# UNITED STATES PATENT AND TRADEMARK OFFICE

10/500,926

<b>Office Action Summary</b>	Application No. 10/500,926	Applicant(s) KIM, DAE-HWAN	
	Examiner Noah C. Hawk	Art Unit 3636

## DETAILED ACTION

Mallookis et al., Figure 5

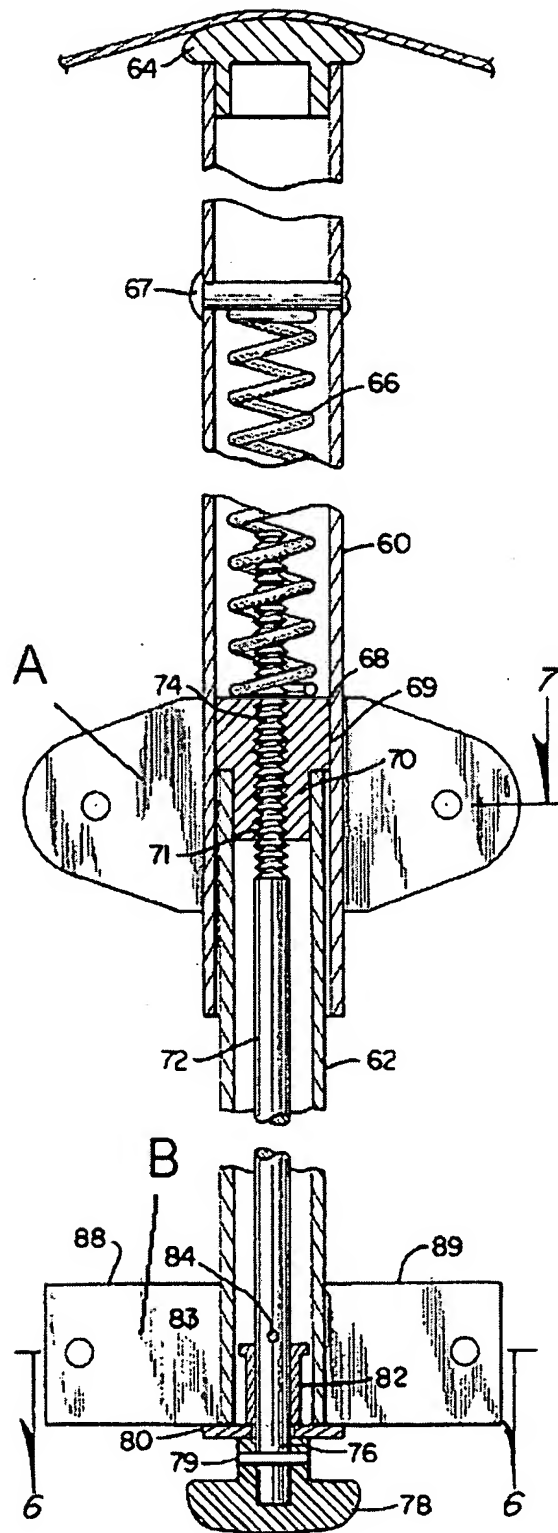
14. Claim 10 is rejected under 35 U.S.C. 103(a) as being unpatentable over Lynch, as modified, as applied to claim 1 above, and further in view of Mallookis et al. in US Patent 5490532. Lynch, as modified, fails to teach an adjustable upper roof column. Mallookis teaches wherein an upper roof column (60) capable of sliding along the upper head connection block (A) is installed on the lower head connection block (B) by penetrating the upper head connection block, an elastic spring (66) is installed under the upper roof column and in a lower roof column to enable height adjustment by erecting the upper roof column, and a rotary handle (78) is installed on the lower head

connection block capable of freely rotating to adjust the displacement of the elastic spring and having one end portion penetrating the elastic spring and fixed to an end portion of the elastic spring capable of freely rotating and the other end portion capable of advancing and retreating by mean of a nut (68) and a screw (74) with respect to the lower head connection block during rotation. It would have been obvious to one of ordinary skill in the art at the time of invention to modify the device of Lynch, as modified, by using an adjustable upper roof column as taught by Mallookis et al., in order to provide "optimum tautness" and an "easily adjusted" tension (see Mallookis, Column 1, lines 55-58) in the cover.
